DESIGNED	KKC20201222	CM4 MODE	VER	PART NUMBER	SHEET 9 OF 34
REVIEWED	JKC		B

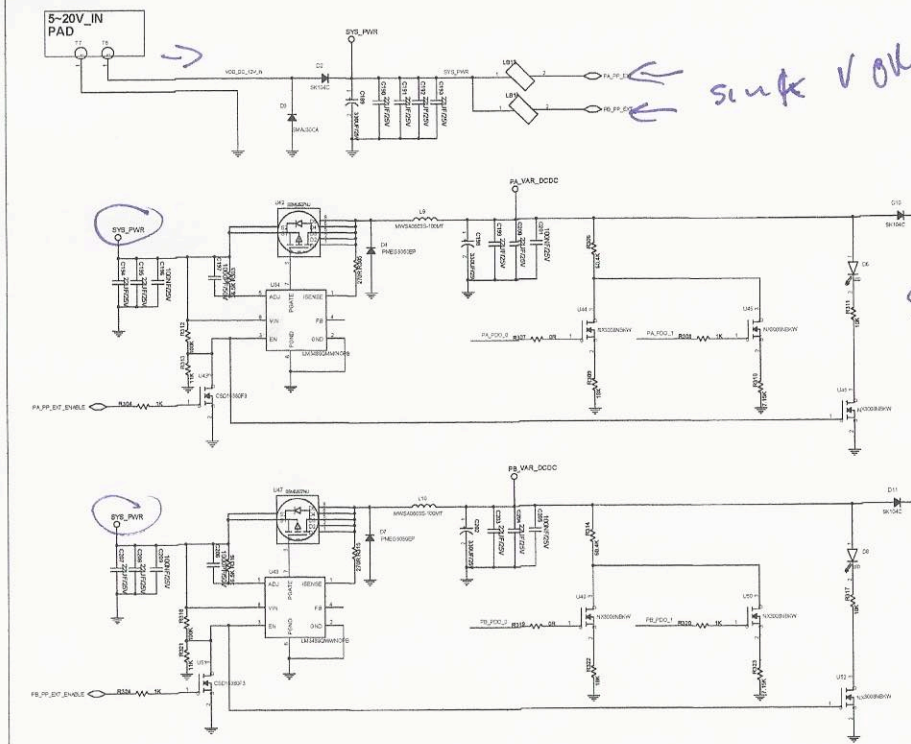
which addresses?

PPHV 3amp source
PPCABLE 0.5A source
PPEXT 3A sink

why?
powering one socket by the other.
